VERMONT YANKEE NUCLEAR POWER CORPORATION

Amendment No. 65
License No. DPR-28

ATTACHMENT TO LICENSE AMENDMENT NO. 65

SAFETY EVALUATION BY THE OFFICE OF NUCLEAR REACTOR REGULATION
SUPPORTING AMENDMENT NO. 65 TO FACILITY OPERATING LICENSE NO. DPR-28

FIGURE 6.1.1
OFFSITE SUPPORT ORGANIZATION

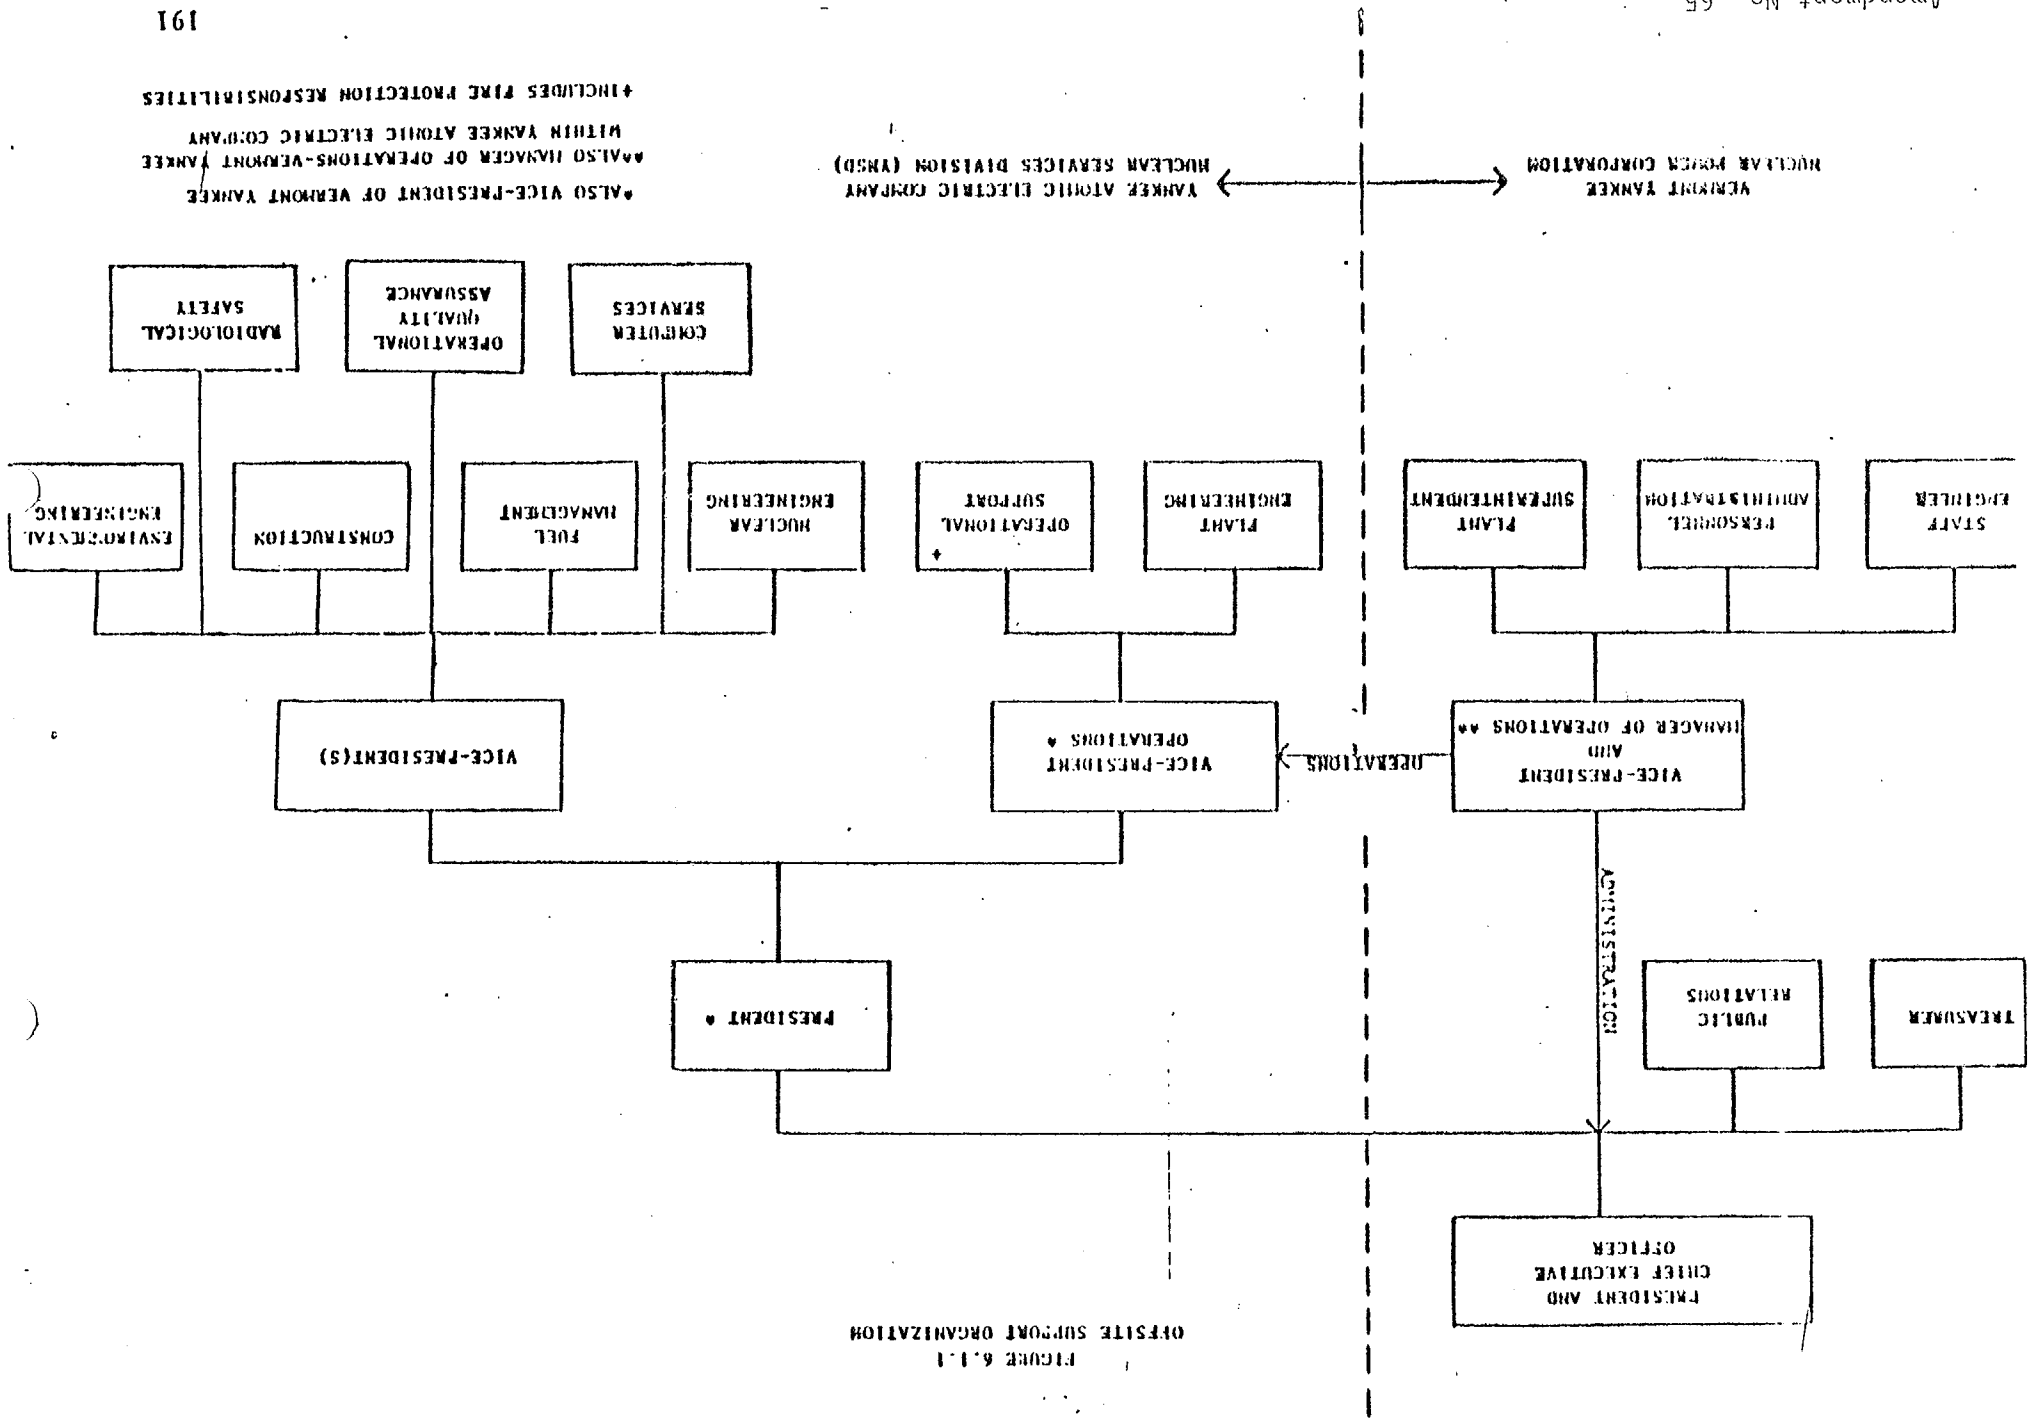
The revised organization charts reflect the presence of a President in the Yankee Atomic Electric Co. which provides services for the Vermont Yankee Nuclear Power Corporation. No change is indicated in the onsite QA support. In all functional areas, the kind of support and amount of support provided from offsite sources is the same as before the change. The position of Technical Services Supervisor has been deleted. Position titles have been updated and membership responsibilities of several professional technical personnel have been changed. The on-site table of organization has been changed to include Shift Technical Advisors.
